Access Compliance Report

(Curb Ramps)

Intersection ID: 53017	Main Street: STEEL_HOUSE_BV	Cross Street: CHARTRES_LN	Location: NE
ADA ID: CB3C1322A45D	Ramp Type: Perp	Initial Pass/Fail: Pass	Overall Compliance: No
Severity Score: 2.5			
Codes/Mitigation Info/Possible Solution		Field Measurements/Component Compliance

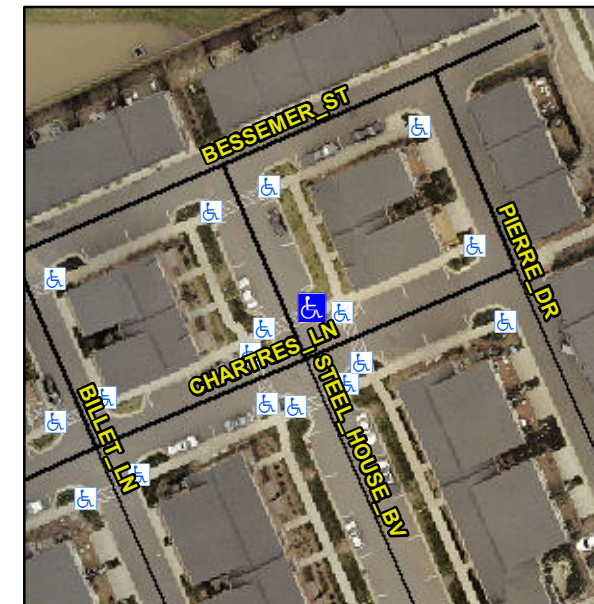
Not Found, R305.1.4, R305.2

Compliance	Description	Data	Compliance	Description	Data
N/A	Ramp Length (in)	139.0	Yes	Ramp Slope (%)	5.7
Yes	Ramp Width (in)	67.0	Yes	Ramp XSlope (%)	0.2
N/A	Flare Type LT	None	N/A	Flare Type RT	N/A
N/A	Flare Slope LT (%)	N/A	N/A	Flare Slope RT (%)	N/A
N/A	Flare Traversable LT?	N/A	N/A	Flare Traversable RT?	N/A
Yes	Landing Length (in)	63.0	Yes	DWS Provided?	Yes
Yes	Landing Width (in)	63.5	Yes	DWS Contrast?	Yes
Yes	Landing Slope (%)	2.0	Yes	DWS Length (in)	24.0
Yes	Landing X Slope (%)	1.6	No	DWS Full Width?	No
N/A	Landing Curb? (Y/N)	No	No	DWS Offset (in)	4.5
N/A	Shared Landing?	No			
Yes	Gutter Ponding?	No	Yes	Gutter Slope (%)	2.4
Yes	Gutter Lip Ht (in)	0.0	Yes	Gutter X Slope (%)	0.6
N/A	Painted X Walk1?	Yes	N/A	Painted X Walk2?	N/A
	X Walk 1 Direction	To SW		X Walk 2 Direction	N/A
N/A	X Walk 1 Width (in)	72.0	N/A	X Walk 2 Width (in)	N/A
	X Walk 1 Slope (%)	1.9		X Walk 2 Slope (%)	N/A
	X Walk 1 X Slope (%)	2.1		X Walk 2 X Slope (%)	N/A

Yes	Ramp inside XWalk1?	Yes	N/A	Ramp inside XWalk2?	N/A
	Road Slope (%)	N/A	N/A	Clear Space?	Yes
	Road X Slope (%)	N/A	N/A	Clear Space to XWalk (in)	N/A
Yes	Any Obstructions?	No	Yes	Storm Grate/Utility Hazard?	No
	Obstruction Type			Storm Grate/Utility Type	
		N/A			N/A
			Yes	Surface Condition? (G/P)	Good

Remove & Replace Entire Ramp.
